# Access Compliance Report

### (Curb Ramps)

Intersection ID: 45281	Main Street: CIERA_NICHOLE_CT	Cross Street: LAKEHILL_RD	Location:	E
ADA ID: 242F1CF55164	Ramp Type: PerpDiag	Initial Pass/Fail: Fail	Overall Compliance: No	Severity Score: 30
Codes/Mitigation Info/Possible Solution		Field Measurements/Component Compliance

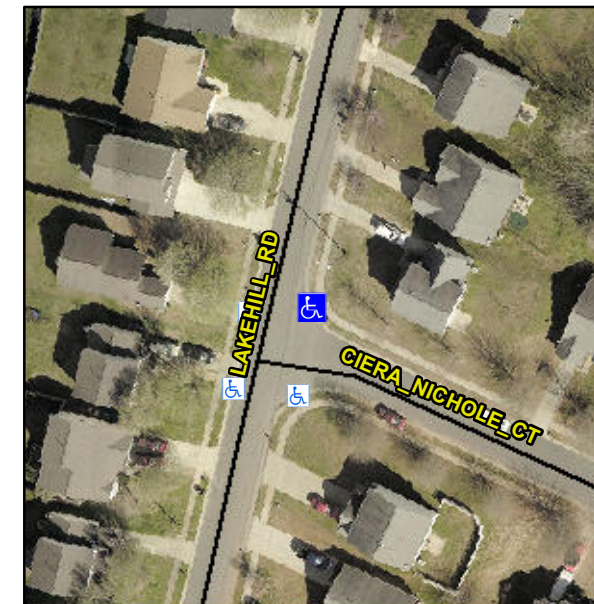
**Remove & Replace Curb Ramp With Two New Directional Ramps or Equivalent.**

**R304.5.1, R304.5.3**
